A585 Windy Harbour to Skippool Improvement Scheme

TR010035

7.11 Environmental Statement Changes and Corrections Document

Version	Date	Status of Version
Rev 0	May 2019	Deadline 2 Submission
Rev 1	July 2019	Deadline 4 Submission

Drawing Title ENVIRONMENTAL STATEMENT REGULATION 5(2)(a) NOISE AND VIBRATION: NOISE MITIGATION SHEET 2 OF 6

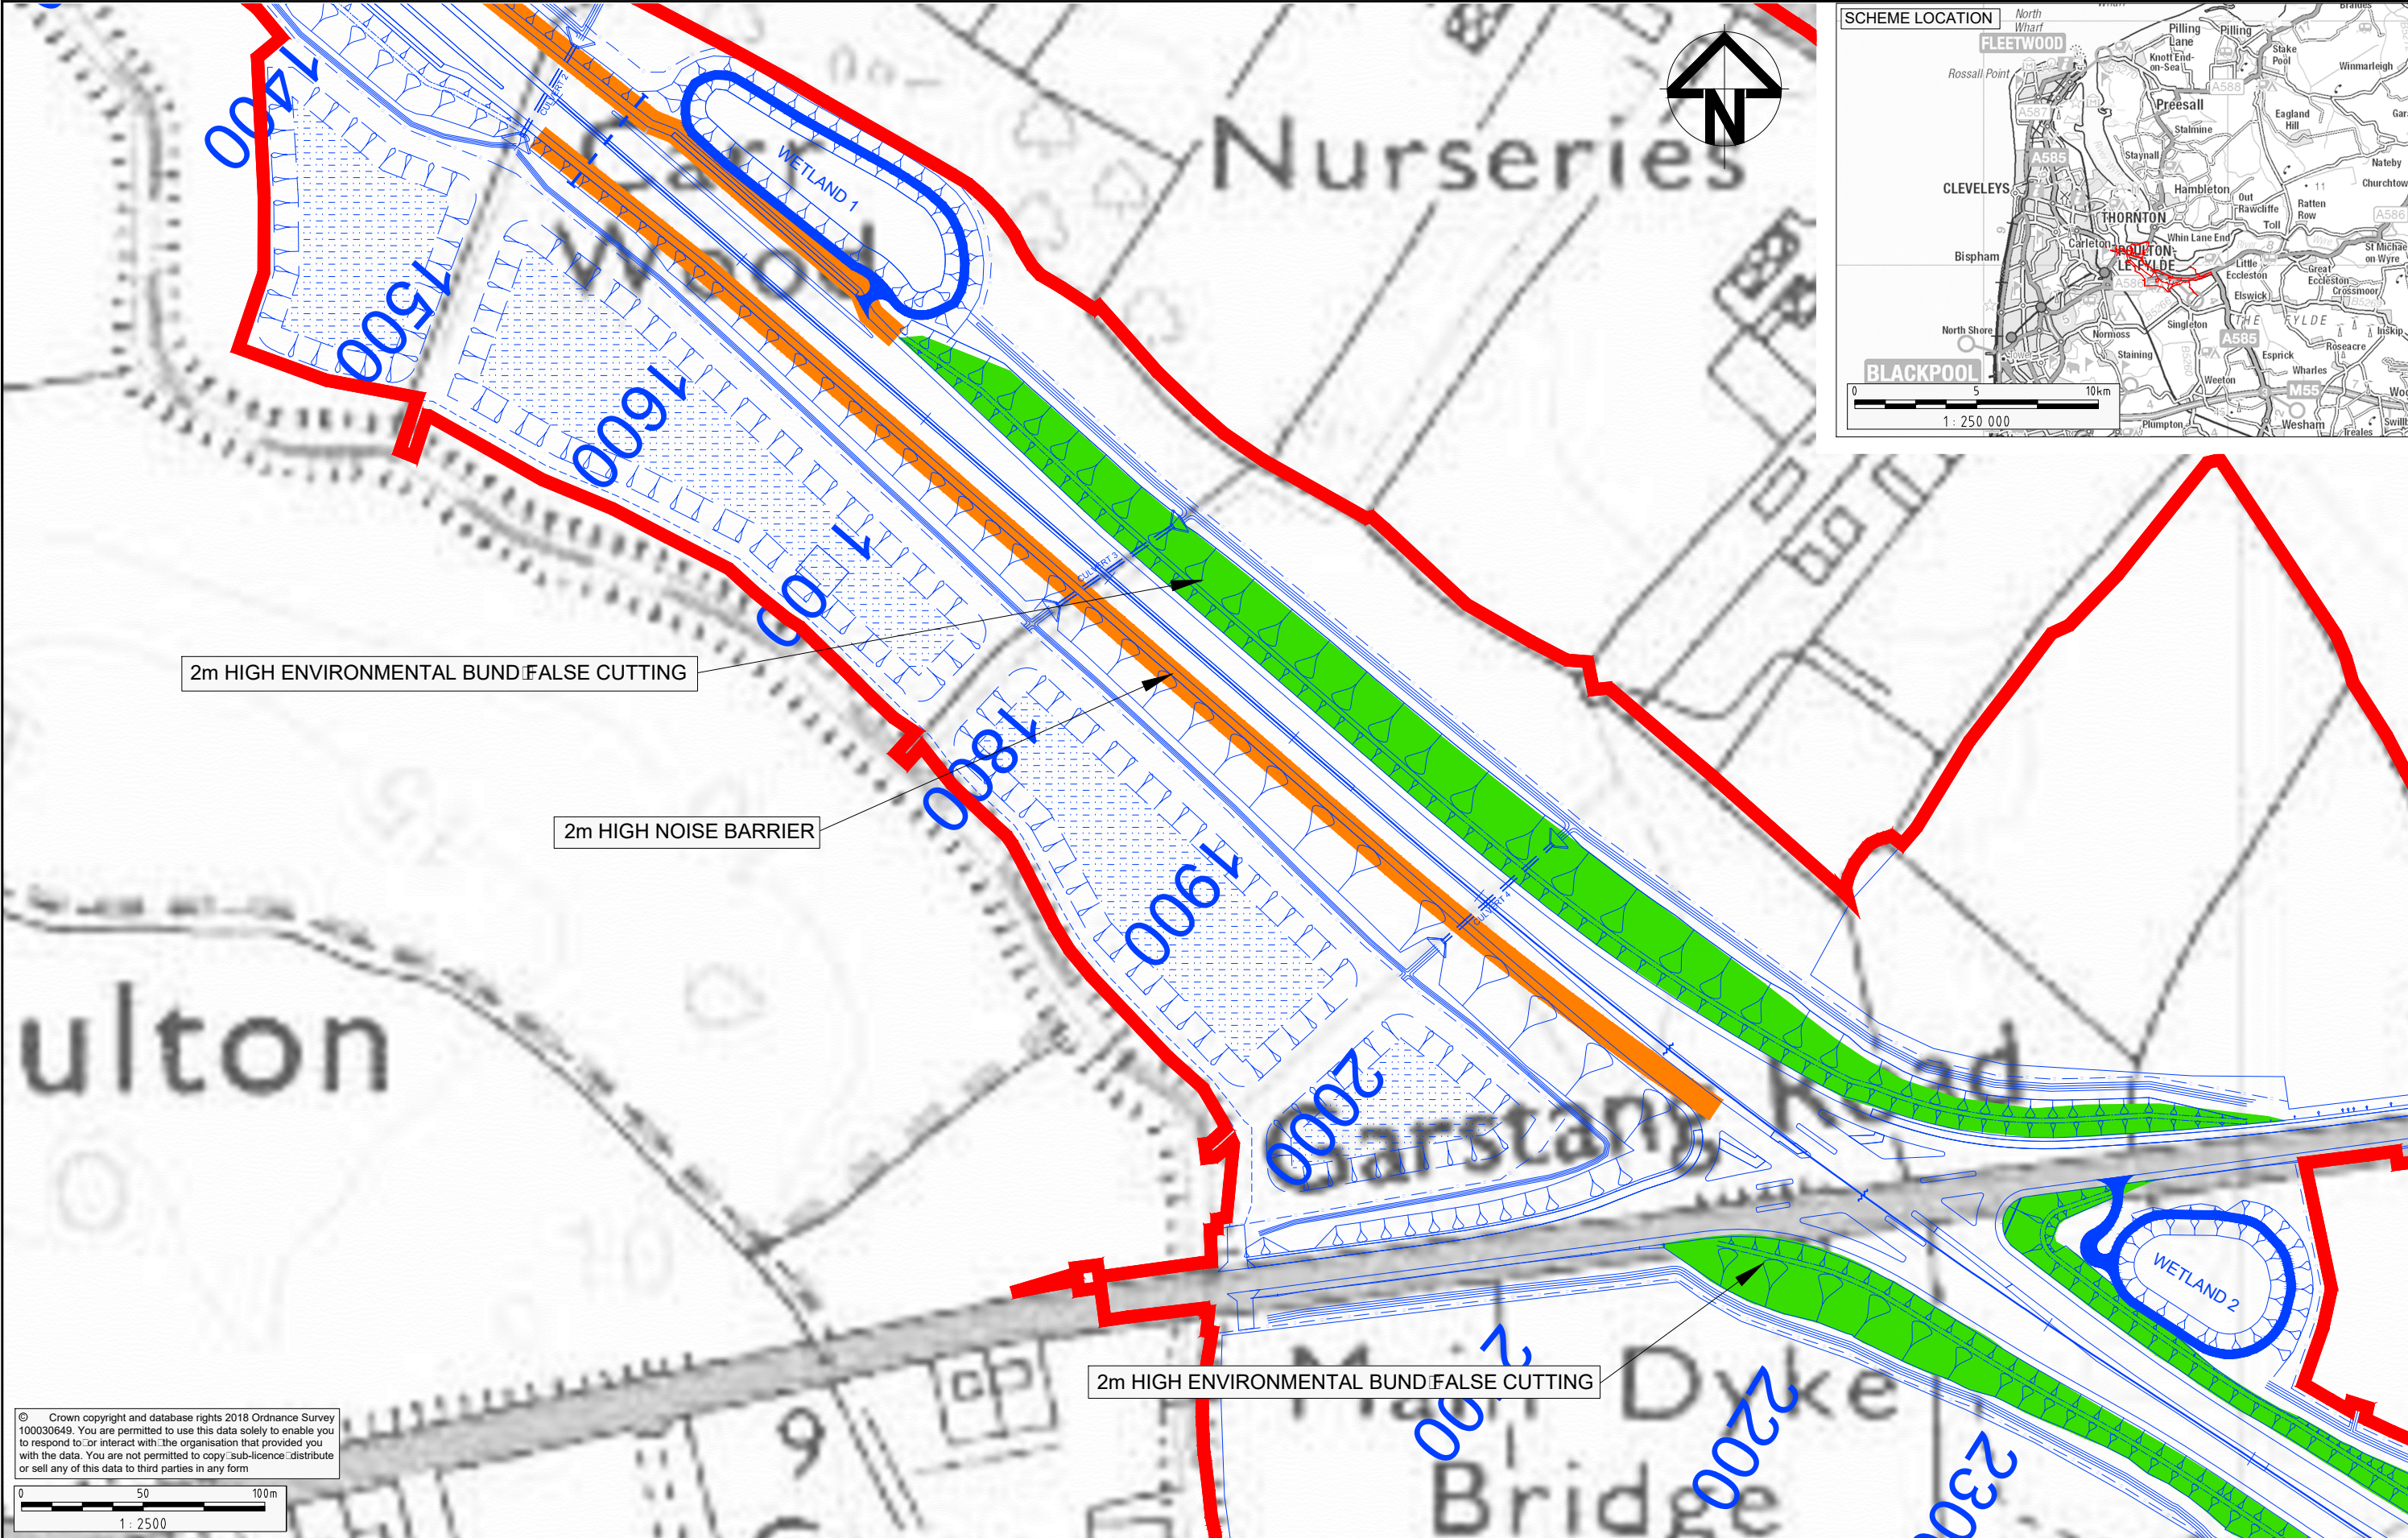
Document Reference Number	Document Name	Amendment Required	Reason
			TR010035/APP/7.10).
6.11	ES Chapter 11: Noise and Vibration	Update to Figure 11.4: Noise and Vibration – Noise Mitigation within the Study Area presented at Appendix D to show heights and locations of earth mounds and acoustic fencing at a larger scale.	Requested by the Inspector within the first round of written questions (document reference TR010035/APP/7.10).

APPENDIX F – Updated Figure 12.2: Road Drainage and The Water Environment - Aquifers

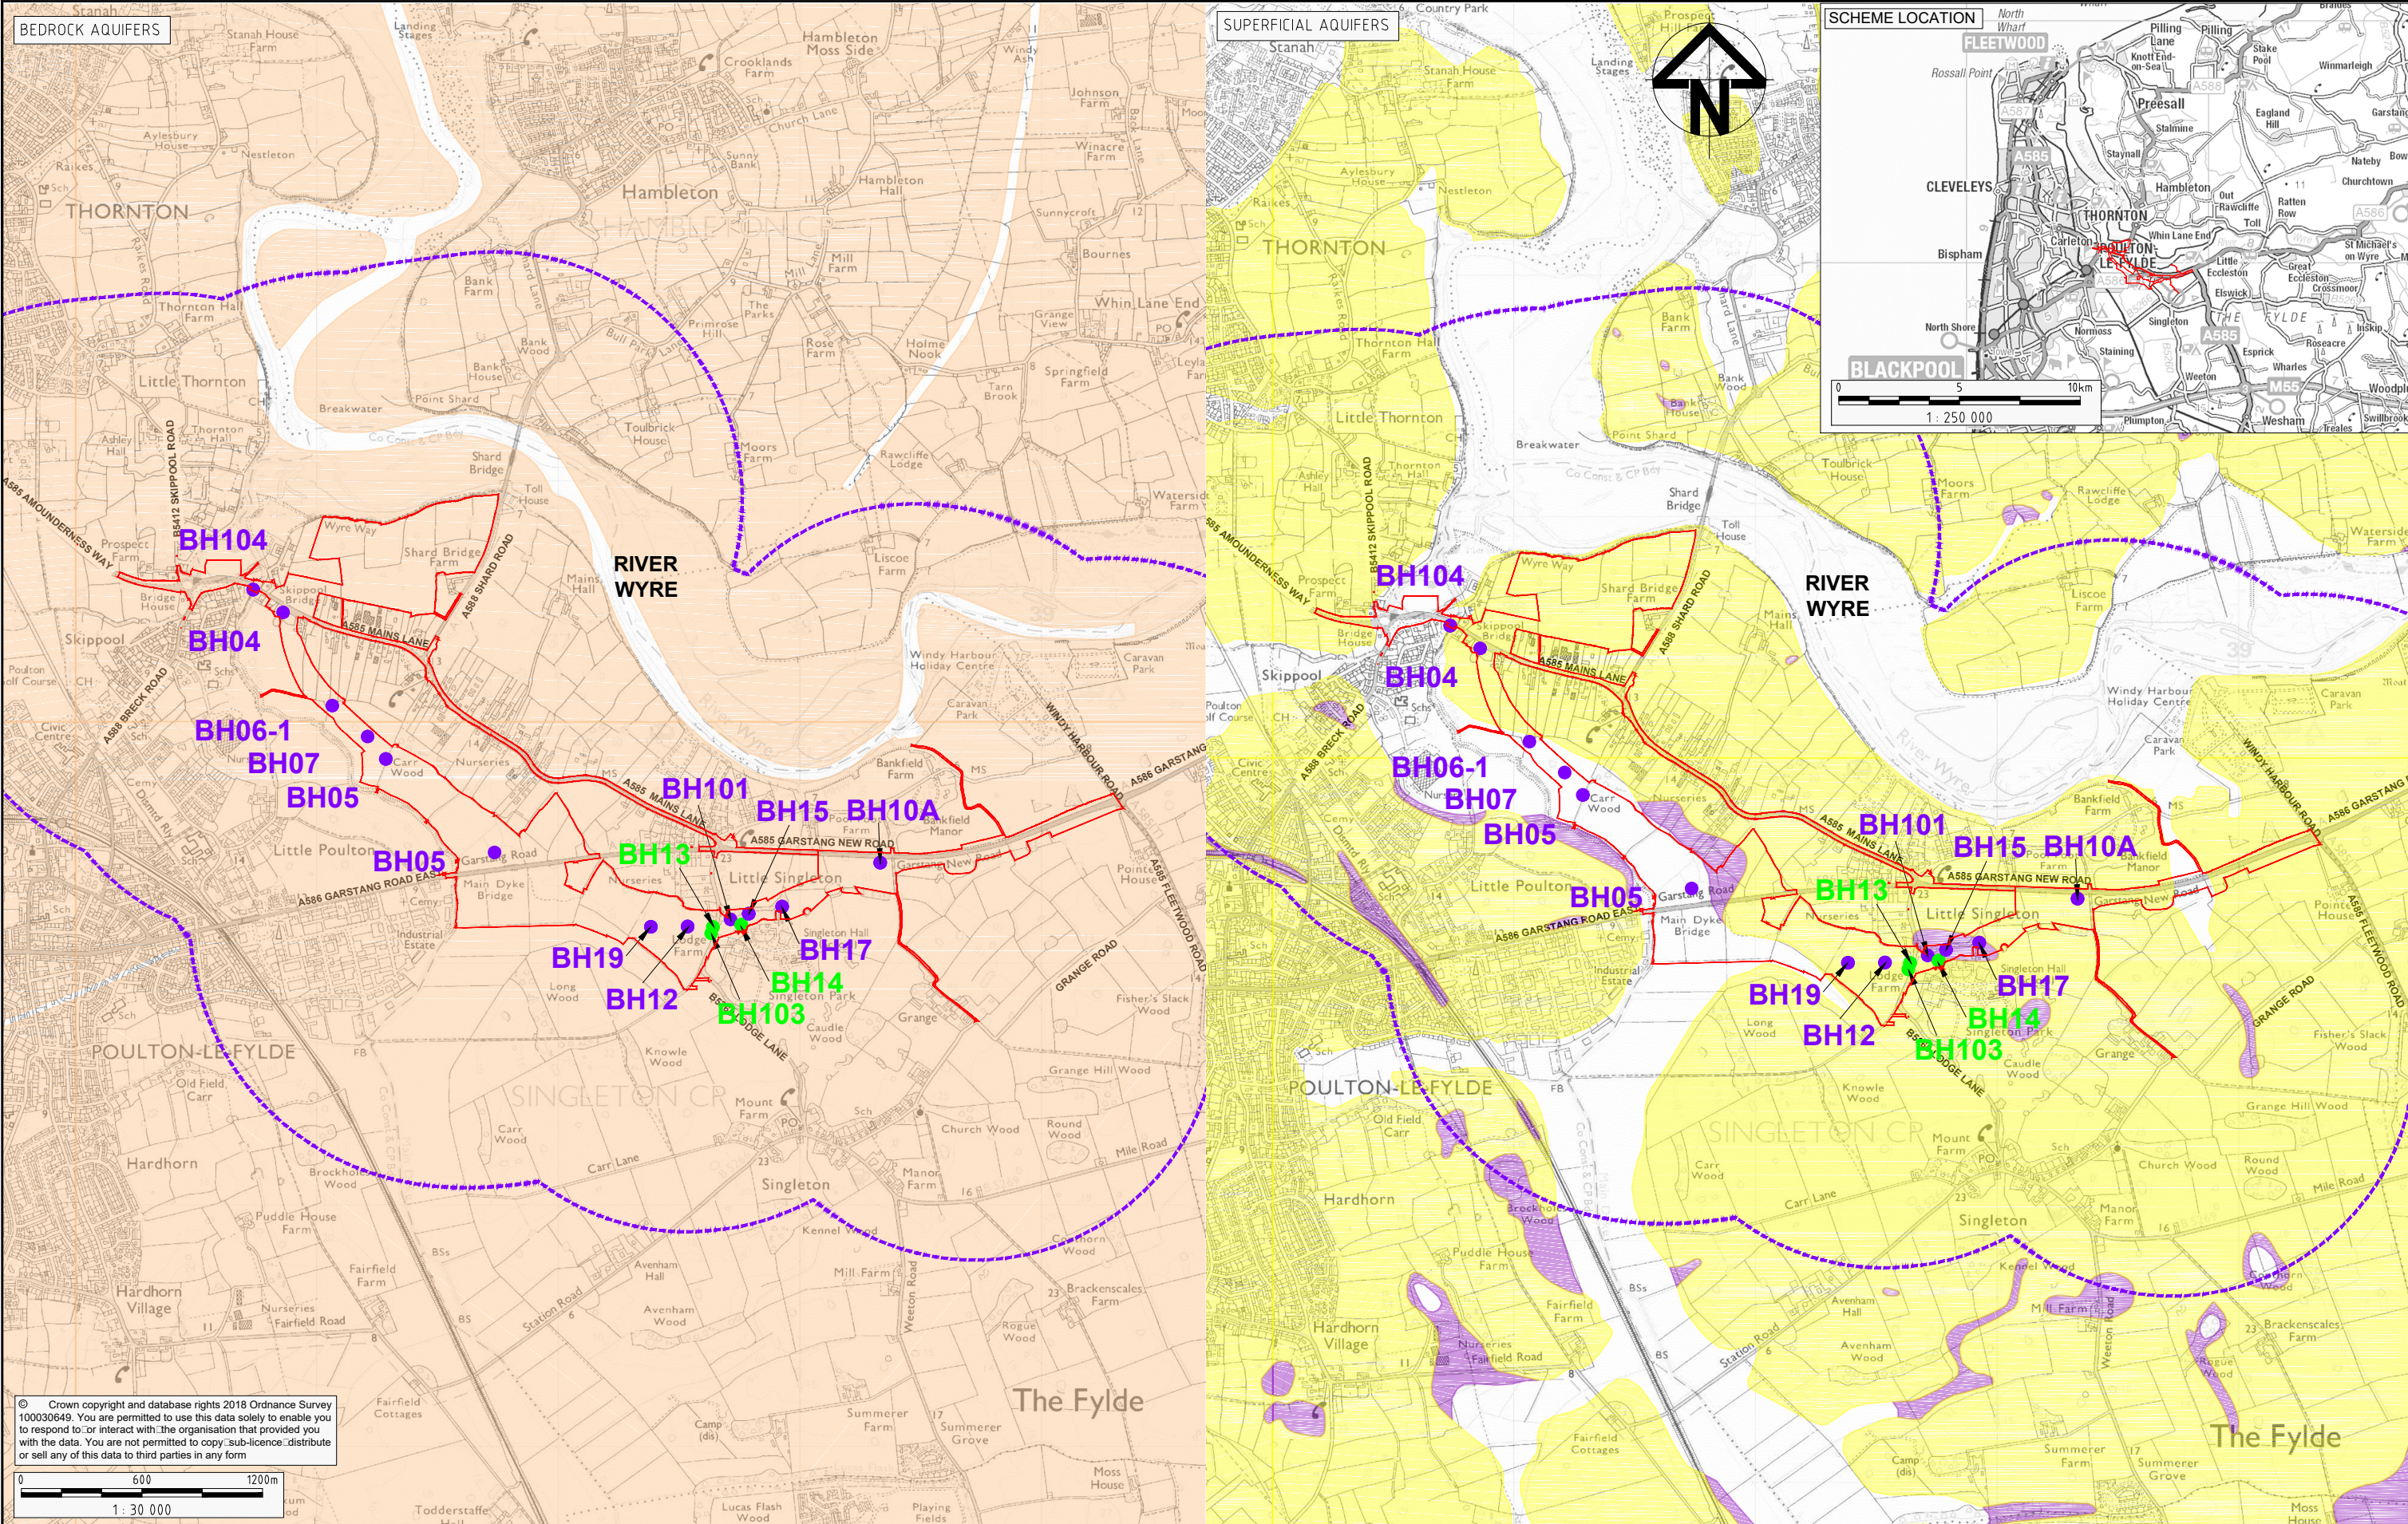
6.12	ES Chapter 12: Road Drainage and the Water Environment	Updated Figure 12.2: Road Drainage and The Water Environment – Aquifers provided at Appendix F to show locations of manual and automated readings for groundwater investigations.	Requested by the Inspector within the first round of written questions (document reference TR010035/APP/7.10).
<u>6.19</u>	<u>ES Chapter 19: Environmental Masterplan</u>	<u>Note: Following construction the temporary flood compensation areas will be decommissioned.</u>	<u>To provide clarity to Lancashire County Council.</u>
